E5062A-04A

S E R V I C E N O T E

E5062A ENA-L RF Network Analyzer, 300 kHz to 3 GHz

A2 receiver board fails System Dynamic Range specification due to a very few clock signal generation component might not work properly.

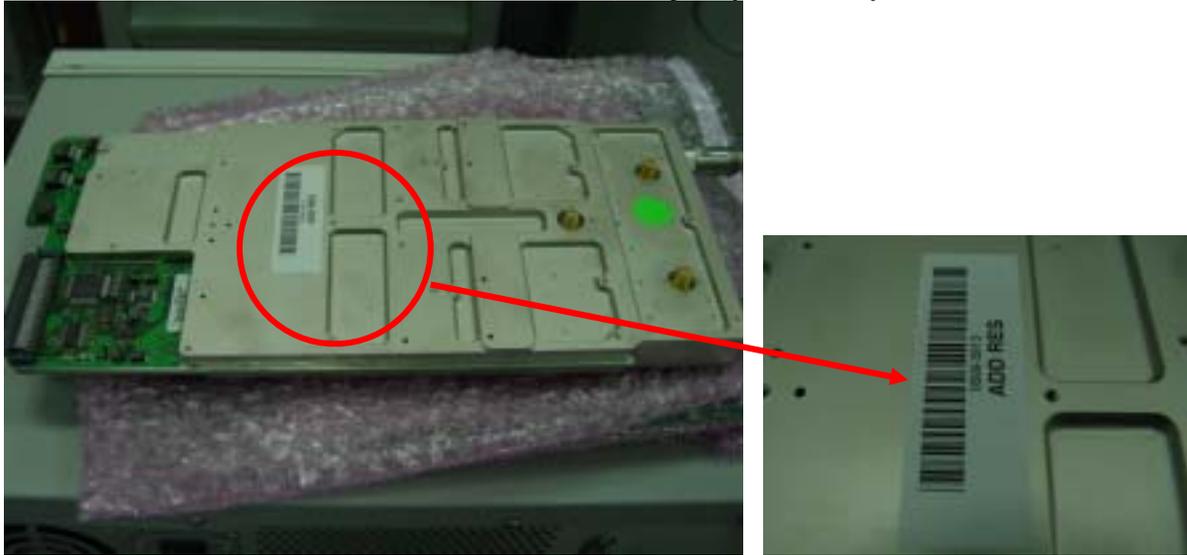
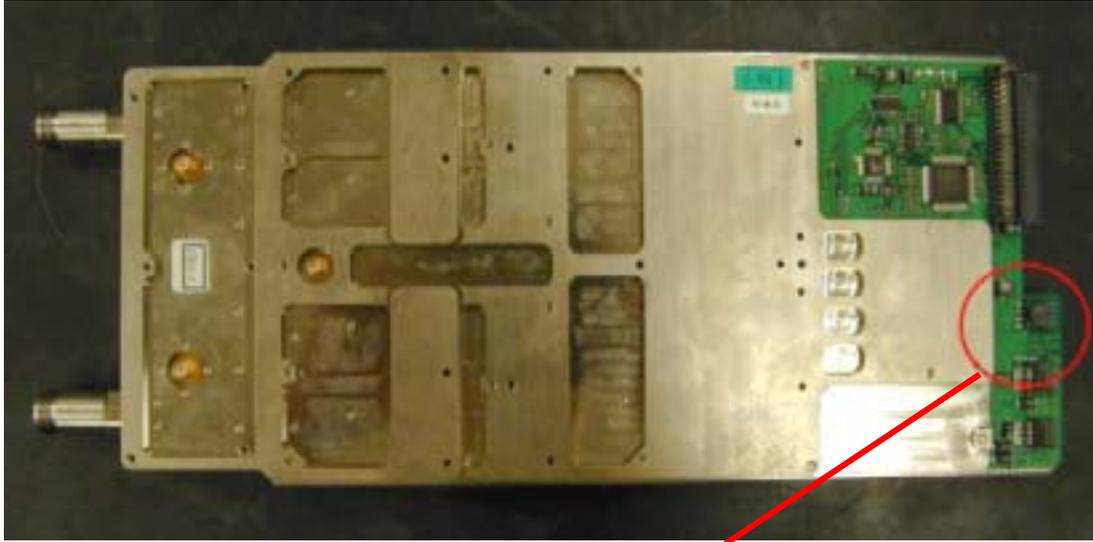
For temporary solution, A2 Receiver Module is reworked by AMC or by CM.
Then for permanent solution, PCA in A2 Receiver Module is revised.

Any of these three cases are “good” A2 receiver module, otherwise return the “bad” module to factory through exchange program.

(1) A2 Receiver Module with “ADD RES” sticker. (Temporary solution by AMC)

(2) A2 Receiver Module with BARCODE which date code suffix is **-200607**-xxxxxx or later
(Temporary solution by CM)

(3) PCA in A2 Receiver Module is changed from E5062-66502 to **E5062-66512**. (Permanent solution)

E5062-66502 should be changed to E5062-66512
